<b>JRPP No:</b>	<b>2010SYE106</b>
<b>DA No:</b>	<b>DA10/1253</b>
<b>PROPOSED DEVELOPMENT:</b>	Staged Development for Residential Subdivision of Two (2) Lots Into 165 Lots - Stage 1: Approval and Works for 165 Lots - Stage 2: Pedestrian Access to Lucas Reserve Lot 1054 DP 1140838 & Lot 1057 DP 1140838 – 442 & 446 Captain Cook Drive, Kurnell
<b>APPLICANT:</b>	Australand Kurnell Pty Limited
<b>REPORT BY:</b>	Brad Harris Environmental Assessment Officer (Planner) Sutherland Shire Council 9710 0859

## Assessment Report and Recommendation

Figure 1: Proposed Subdivision Layout (southern part of site)

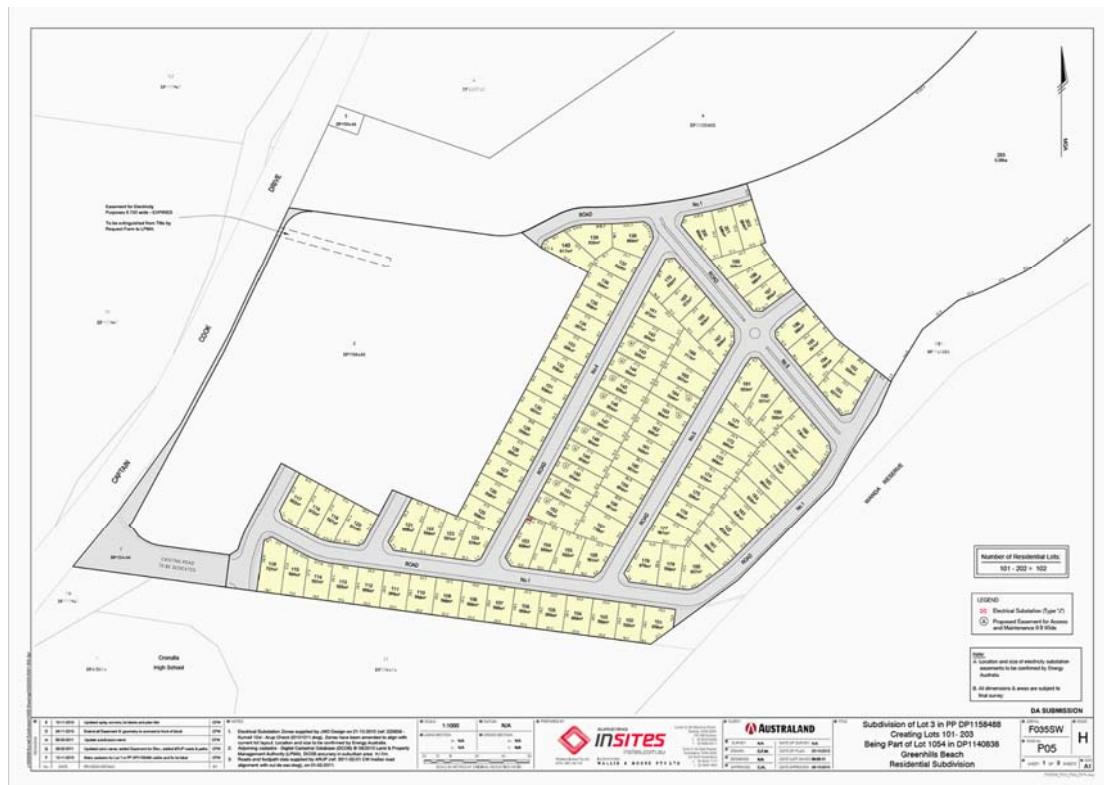
*With regard to the Australand subdivision and its internal road network, I still have some concerns with some of the design aspects, these being:*

- The proposed reduced road carriageway widths with parking on only one side of the road will potentially create enforcement and ongoing maintenance issues for Council. It is considered that under the proposed arrangements, the public road system will lack flexibility with regard to seasonal parking demands associated with use of the adjacent open space areas and also changing demographics associated with resident and resident visitor parking (eg: families with teenagers).*
- The geometry of the intersection of both legs of road 1 and the main entry road remains a concern (note also proposed connection to Breen's land). From a logical planning perspective, it would be*

*preferable to create a single roundabout controlled intersection that services the entry from Captain Cook Drive both legs of Road 1, and access to the Breen's site. I'm not sure why this was not incorporated by Australand in their subdivision design other than it may impact on residential yield. Similarly it is also felt that best practice in intersection design has been compromised by the geometry of both the intersections of roads 1, 4 and 6, and roads 1 and 3 in order to obtain optimum yield of residential lots.*

- *Closer consideration will need to be given to placement of trees at and on approach to each intersection with respect to provision of adequate sight distances”.*

To provide for the option of allowing some informal street parking whilst not significantly affecting the applicant's design it is proposed to impose a design change condition (Condition 20) which will require 9m wide carriageways, 2.1m wide parking lane on one side of the road and roll kerb on the other side of the road which will allow for informal parking on that side of the road without affecting two way traffic movement.

To facilitate the above, a 'design change' condition (Condition 20) is proposed, which requires a roll kerb to be provided in Road 1 adjacent to Wanda Reserve. This will not affect the proposed lot layout.

The concern regarding sight distances at some intersections has been addressed by a ‘design change’ condition (Condition 20) to ensure compliance with AUSROADS.

Figure 2: Proposed Subdivision Layout (northern part of site)

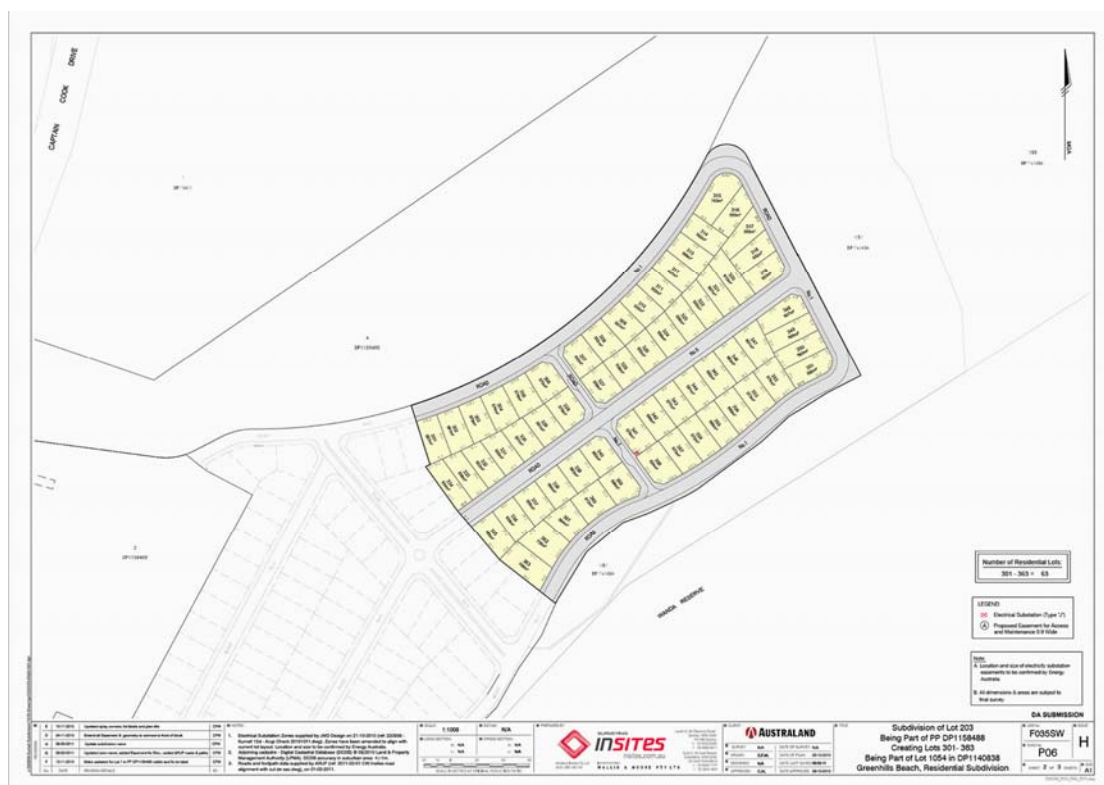
*“...the RFS is relatively happy with the layout submitted, one concern however relates to the proposed Asset Protection Zones (APZs). Whilst it is noted that the land to the immediate south of the site has been subject to subdivision and is likely to be developed, the current situation requires a 15m APZ to the southern boundary of the site. The application does not consider how this APZ will be provided until such time as the land to the south is redeveloped. Without this temporary APZ, Lots 101 and 102 would be subject to a high level of bushfire risk.”*

The RFS have undertaken to provide a formal response and this will be presented to the JRPP as soon as it is received. The draft conditions of consent provided with this report include a standard condition requiring any requirements specified by an Integrated Development Authority (in this case the RFS) to be met at Construction Certificate stage.
